Standardization of technical and safety requirements in inland navigation: Recommendations on Harmonized Europe-Wide Technical Requirements for Inland Navigation Vessels (resolution No. 61, revision 2)

Amendment proposals to the annex to resolution No. 61, revision 2, based on the European Standard laying down technical requirements for inland navigation vessels, edition 2021

Note by the secretariat

Figure 2

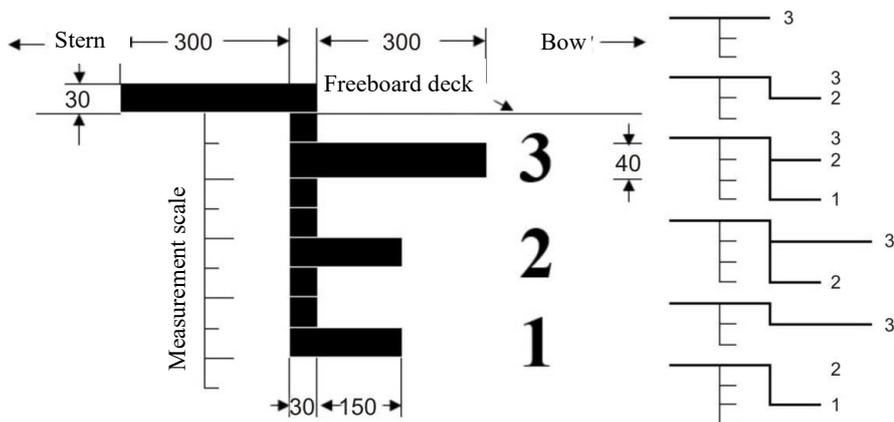
3. The plane of maximum draught shall be indicated by means of highly visible, indelible draught marks.
4. Draught marks are to be designed as follows:
 - a) The topmost draught mark points towards the stern and is a rectangle 300 mm long and 30 mm high, the baseline of which is horizontal and coincides with the plane of the deepest authorised draught. If the topmost draught mark is the one applicable to zone 3, it is 40 mm high.

- b) The additional draught marks to be added point towards the bow and the following provisions apply:
 - aa) Draught marks for zone 3 comprise a rectangle 300 mm long and 40 mm high

- bb) Draught marks for zones 1 and 2 comprise a rectangle 150 mm long and 30 mm high, the baseline of which is horizontal and coincides with the plane of the maximal permissible draught.

- c) If the draught mark to be added for zone 3 or 4 coincides with the uppermost draught mark, the latter can be dispensed with.
5. The number of the zone, in characters 60 mm high × 40 mm deep, is to be added next to the draught marks towards the bow; in the case of zone 4, the number can be dispensed with.

6. The draught marks according to (4) and (5) and their orientation are to be in accordance with Figure 2.

Figure 3

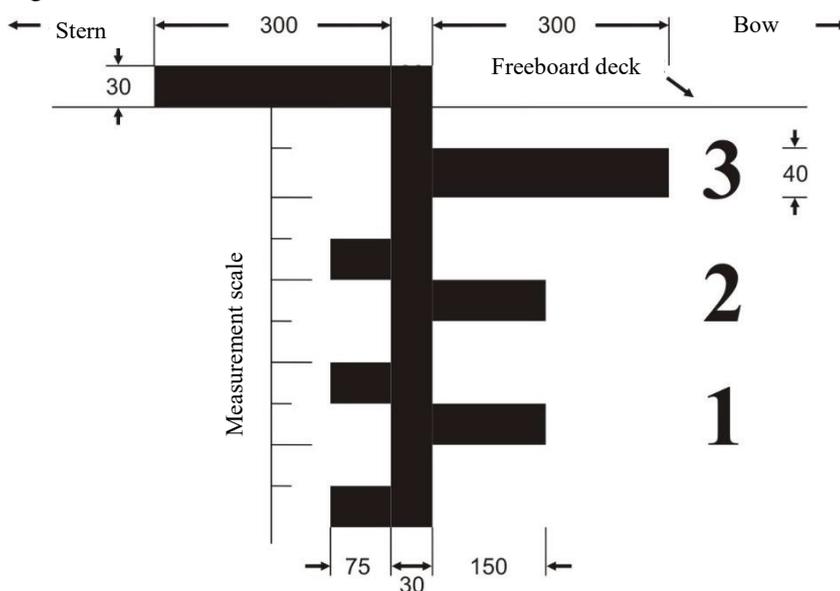
12. In the case of vessels with open holds, in addition to the provisions of (7) the draught marks for the relevant zones are to be supplemented by a rectangle 75 mm long by 30 mm high, pointing aft, the base of which is horizontal and coinciding with the level of the maximum permissible draught for navigation in the zone in question with open holds.

13. The draught marks according to (12) and their orientation are to be in accordance with Figure 3.
